Title - Sujet 135 kV Substation Upgrade	
Solicitation No. - N° de l'invitation F1700-150694/A	Amendment No. - N° modif. 001
Client Reference No. - N° de référence du client F1700-150694	Date 2015-06-29
GETS Reference No. - N° de référence de SEAG PW-\$PWY-005-7532	
File No. - N° de dossier PWY-5-38046 (005)	CCC No./N° CCC - FMS No./N° VME
Solicitation Closes - L'invitation prend fin at - à 02:00 PM on - le 2015-07-13	Time Zone Fuseau horaire Pacific Daylight Saving Time PDT
F.O.B. - F.A.B. Plant-Usine: <input type="checkbox"/> Destination: <input checked="" type="checkbox"/> Other-Autre: <input type="checkbox"/>	
Address Enquiries to: - Adresser toutes questions à: Pillay, Sal (PWY)	Buyer Id - Id de l'acheteur pwy005
Telephone No. - N° de téléphone (604) 775-9386 ()	FAX No. - N° de FAX (604) 775-6633
Destination - of Goods, Services, and Construction: Destination - des biens, services et construction: DFO - Conuma River Hatchery - Vancouver River, BC

Addendum # 1

SCALE 1:30				FISHERIES AND OCEANS CANADA REAL PROPERTY AND TECHNICAL SUPPORT				SCALE							
								CONUMA RIVER HATCHERY CONTRACT NO. F1700-150694 138 kV SUBSTATION UPGRADE OIL WATER SEPARATOR AND DETAILS				AS SHOWN

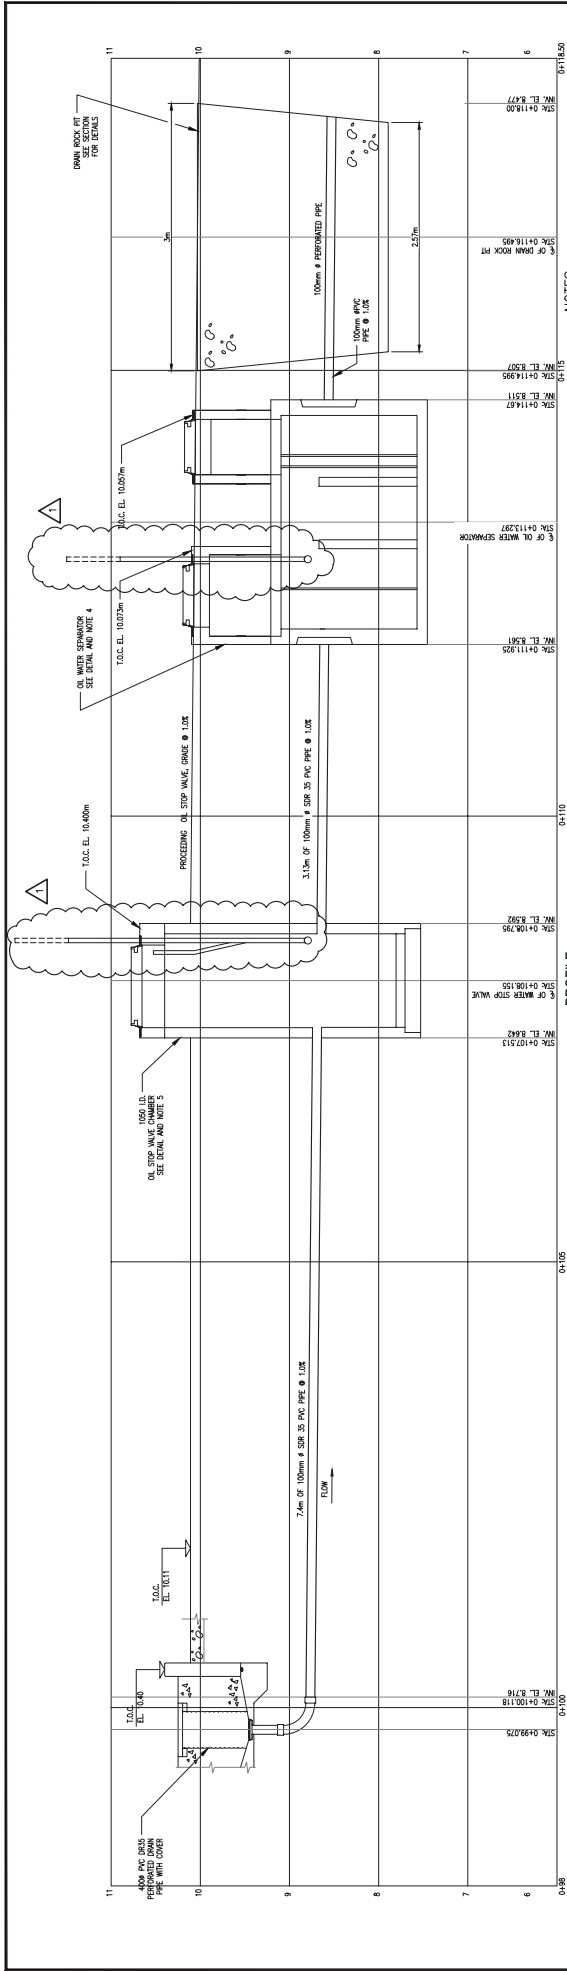
1. Drawing 32-18-284 Rev.1 supersedes / replaces its previously issued Rev. 0.
2. Drawing 32-18-289 Rev. 1 supersedes / replaces its previously issued Rev. 0.

6. After Item 3.5.3 **ADD**;
.4 Liquid Level Indicators for the oil stop chamber and the oil water separator, shown on Drawing 32-18-284, shall be designed and installed:

-
- .1 with the top of the rigid tube extended and secured above grade between 800 and 900mm and its bottom opening about 600mm above the float,
 - .2 with the aluminum disc cap attached to the rod such that the rod, and rain, etc., will not fall through the RPVC tube,
 - .3 with the float attached to fiberglass rod initially at rest with float base at the top elevation of the outlet pipe opening,
 - .4 so that when the water/oil level in the chamber or oil water separator rises up to 600mm above the top of the outlet pipe, the painted portion of the fibreglass rod will be correspondingly exposed above the tube and readily visible above grade by hatchery personnel, and
 - .5 all materials shall be durable and capable of performing in all weather conditions without corrosion and the moving components shall also be lightweight.
